SERVICE BULLETIN

N° 139-576

ATA 21 - VENTILATION AND WATER DRAIN LINES VARIANT

This Service Bulletin is issued in order to provide the necessary instruction on how to perform the installation of cabin ventilation variant P/N 3G2140P00911 or P/N 3G2140P01011, water drain lines variant P/N 3G3070P00411 and VCS condenser pack seal retromod P/N 3G2150P01411.

Figure 3

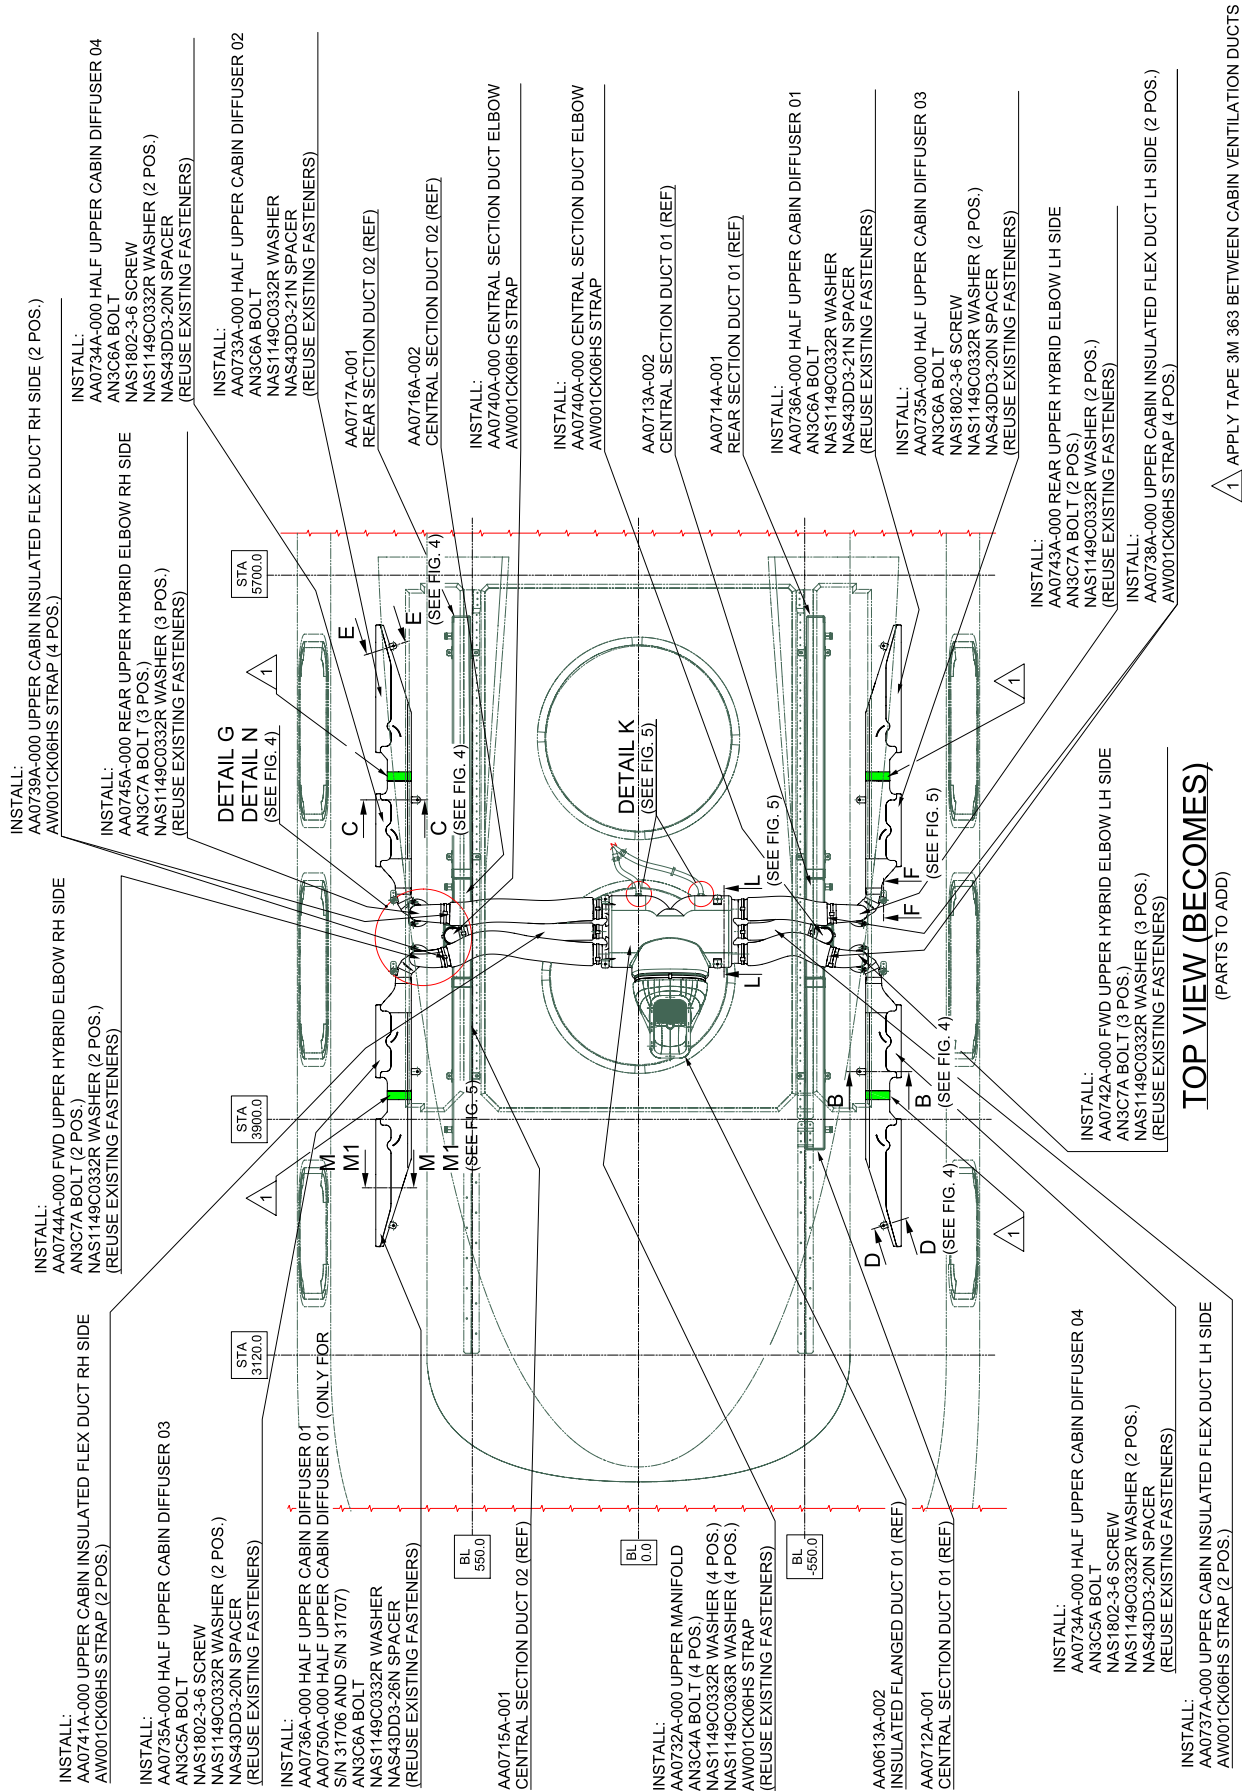
- 2.24 With reference to Figure 3 Section L-L, install n°1 upper manifold P/N AA0732A-000 using n° 1 strap P/N AW001CK06HS and existing hardware.
 - 2.25 With reference to Figure 3 Detail K, install on upper manifold P/N AA0732A-000 n°2 water drain lines using existing hardware.

- 2.26 With reference to Figure 3 Section M-M, install n°1 half upper cabin diffuser 01 P/N AA0736A-000, using n°1 bolt P/N AN3C6A and existing hardware.

- 2.29 With reference to Figure 3 Section C-C, install n°1 half upper cabin diffuser 04 P/N AA0734A-000, using n°1 bolt P/N AN3C6A, n°1 screw NAS1802-3-6, n°1 spacer P/N NAS43DD3-20N and existing hardware.

- 2.30 With reference to Figure 3 Section E-E, install n°1 half upper cabin diffuser 02 P/N AA0733A-000 using n°1 bolt P/N AN3C6A, n°1 spacer P/N NAS43DD3-21N and existing hardware.

- 2.33 With reference to Figure 3 Section F-F, install n°1 half upper cabin diffuser 03 P/N AA0735A-000 using n°1 bolt P/N AN3C6A, n°1 spacer P/N NAS43DD3-21N and existing hardware.

- 2.35 With reference to Figure 3 Section B-B, install n°1 half upper cabin diffuser 04 P/N AA0734A-000, using n°1 screw NAS1802-3-6, n°1 spacer P/N NAS43DD3-20N and existing hardware.

- 2.36 With reference to Figure 3 Section D-D, install n°1 half upper cabin diffuser 02 P/N AA0733A-000 using n°1 bolt P/N AN3C6A and existing hardware.

- 2.39 With reference to Figure 3 Detail G Detail N, install n°1 FWD upper hybrid elbow RH side P/N AA0744A-000 using existing hardware.
 - 2.40 With reference to Figure 3, install n°1 upper cabin insulated flex duct RH P/N AA0739A-000 using n°2 straps P/N AW001CK06HS.

Figure 6

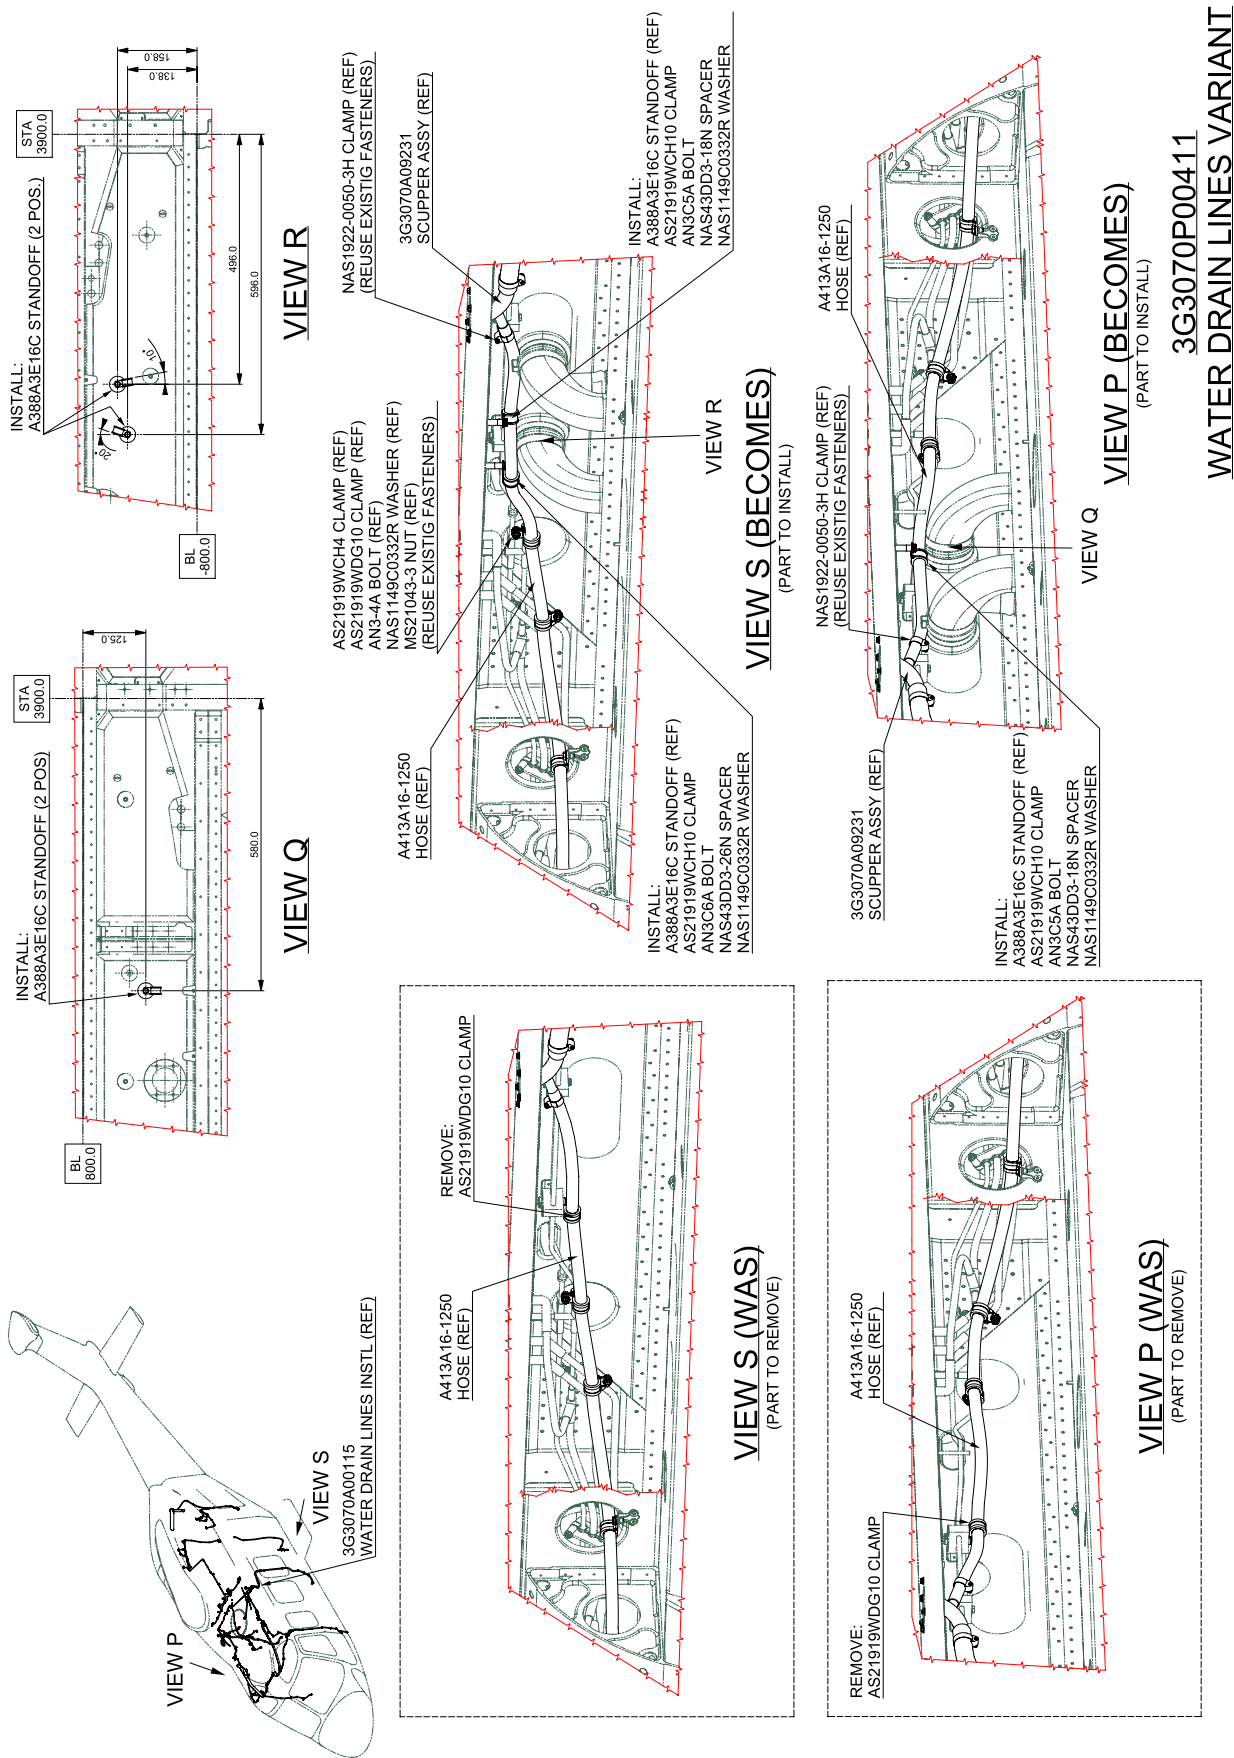
- If necessary, seal all connections between hoses and rigid pipes using sealant MC-780 A.
- 2.1 With reference to Figure 6 View S WAS, remove n°1 clamp P/N AS21919WDG10.

- 2.2 With reference to Figure 6 View R, install n°2 Standoff P/N A388A3E16C.
 - 2.3 With reference to Figure 6 View S BECOMES, routing the existing drain line hose P/N A413A16-1250 using on FWD standoff installed on Step 2.1 n°1 spacer P/N NAS43DD3-26N, n°1 clamp P/N AS21919WCH10, n°1 washer P/N NAS1149C0332R and n°1 bolt AN3C6A.

- 2.4 With reference to Figure 6 View S BECOMES, routing the existing drain line hose P/N A413A16 using on AFT standoff installed on Step 2.1 n°1 spacer P/N NAS43DD3-18N, n°1 clamp P/N AS21919WCH10, n°1 washer P/N NAS1149C0332R and n°1 bolt AN3C5A.

- 2.5 With reference to Figure 6 View P WAS, remove n°1 clamp P/N AS21919WDG10 and existing hardware.
 - 2.6 With reference to Figure 6 View Q, install n°1 Standoff P/N A388A3E16C.

- 2.7 With reference to Figure 6 View P BECOMES, routing the existing drain line hose P/N A413A16-1250 using on standoff installed on Step 2.6 n°1 spacer P/N NAS43DD3-18N, n°1 clamp P/N AS21919WCH10, n°1 washer P/N NAS1149C0332R and n°1 bolt AN3C5A.

Figure 8

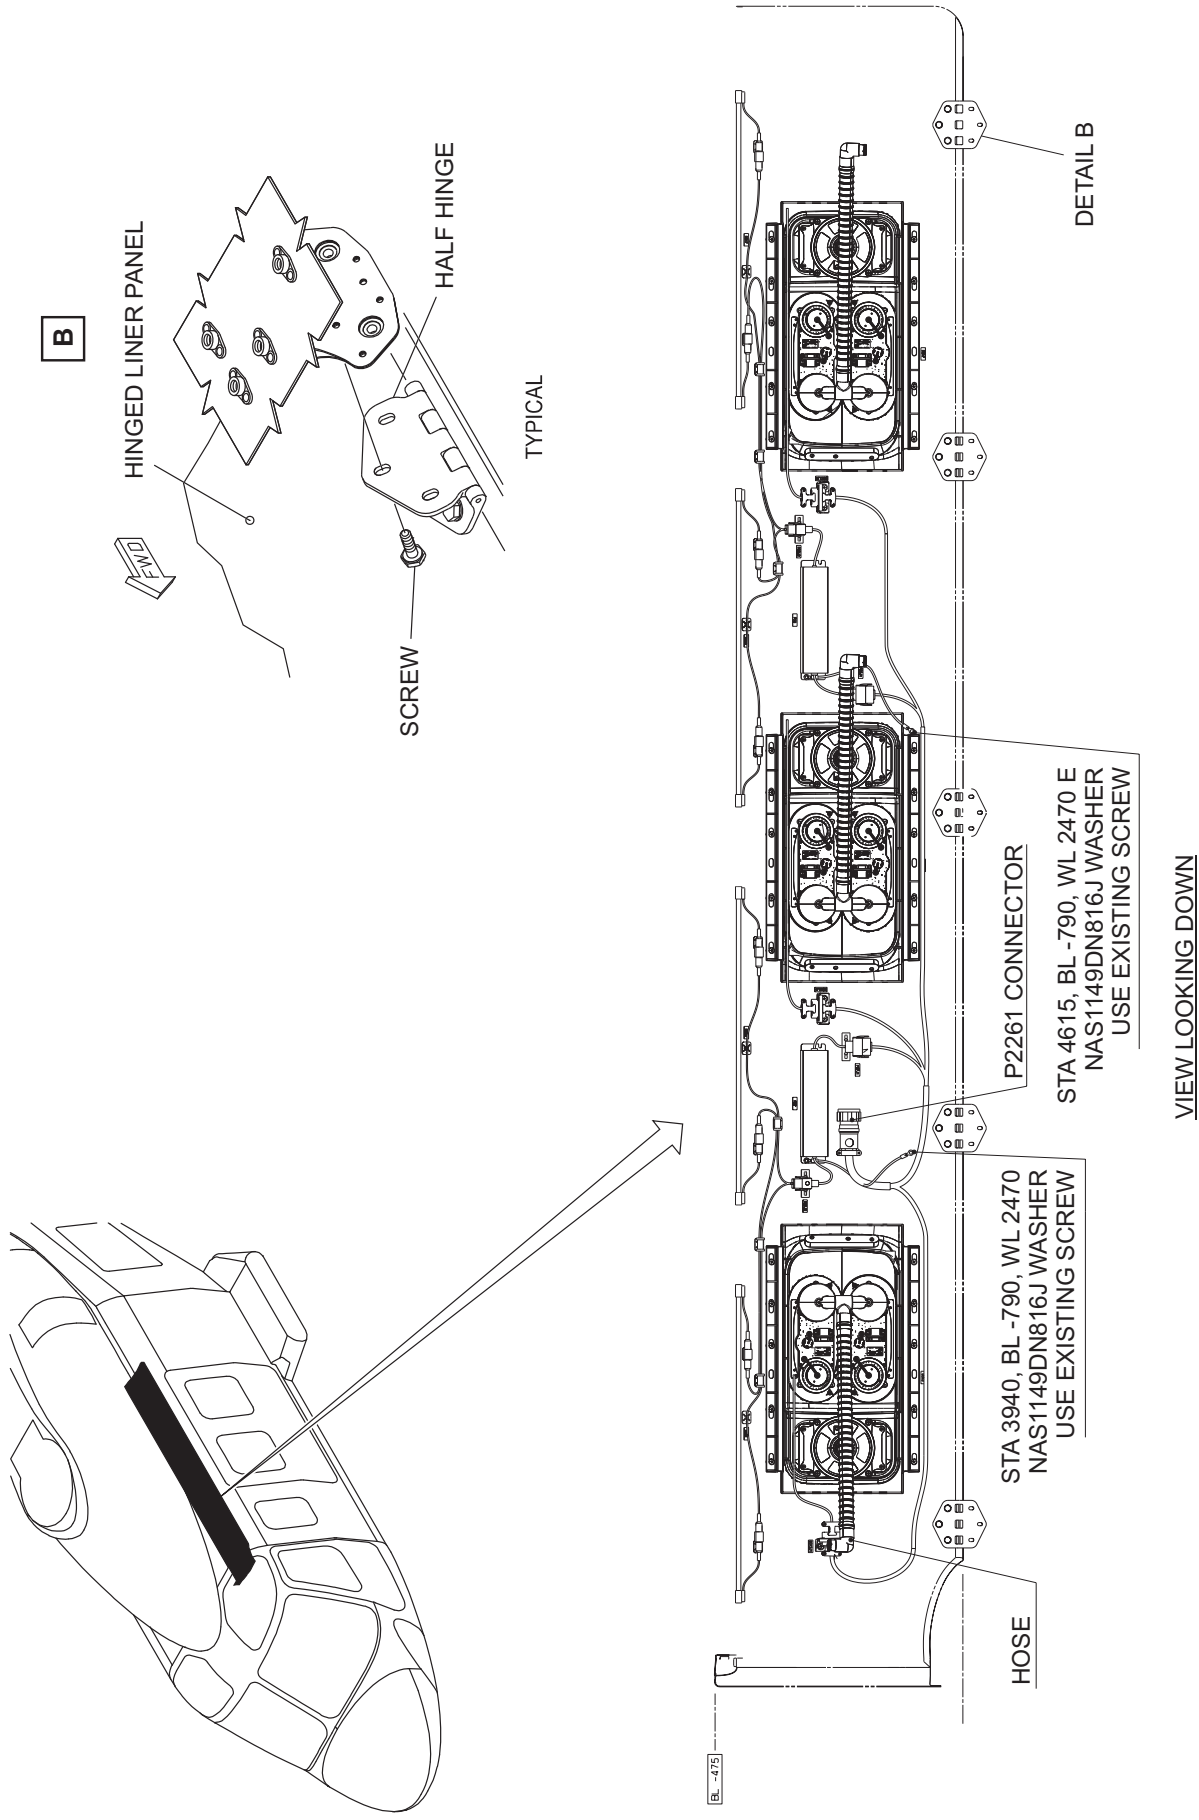
6. With reference to Figure 8, repeat steps 2 thru 5 and remove the liner assy hinged LH.
7. With reference to Figure 9, install the liner assy hinged RH P/N 3G2580A78031CS01 on the structure as described in the following procedure:

10. With reference to Figure 8, repeat steps 7 thru 9 and install the liner assy hinged LH P/N 3G2580A78131CS01.
11. In accordance with weight and balance changes, update the Chart A (see Rotorcraft Flight Manual, Part II, Section 6).

Figure 9

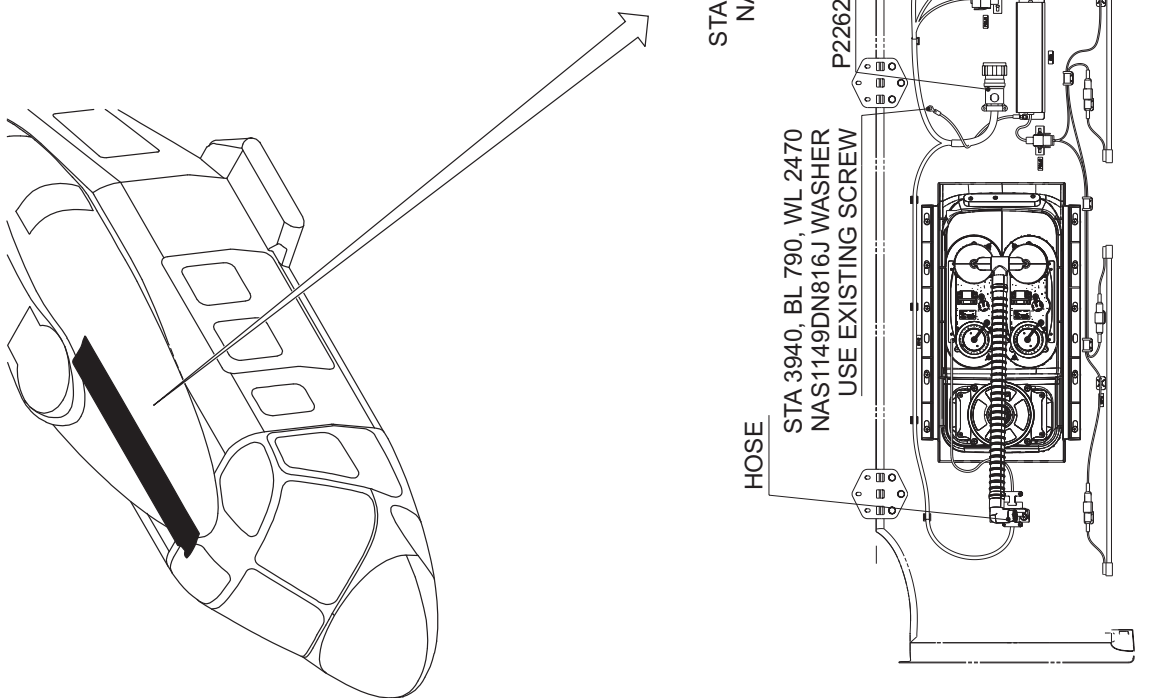
2. With reference to Figure 9, carefully release the four camlocks that attach the liner assy hinged RH to the structure.
3. Carefully lower the liner assy hinged RH as the cables and the structure will let.

4. With reference to Figure 9, disconnect the three gasper hoses from the passenger service units, the three bonding jumpers from the structure and the P2262 connector.

5. With reference to Figure 9, safety hold the lining panel and remove the fifteen bolts from the five half hinges and remove the linear assy hinged RH from the structure. Retain remove hardware for later re-use.

- 7.3 Attach the five half hinges to the structure by means of previously removed, fifteen bolts. Tighten the bolts.
8. With reference to Figure 9, connect the three gasper hoses to the passenger service units and the P2262 connector.

9. With reference to Figure 9, install the three bonding jumpers using existing fixing points on the structure by means of n°3 washers P/N NAS1149DN816J and previous removed screws.
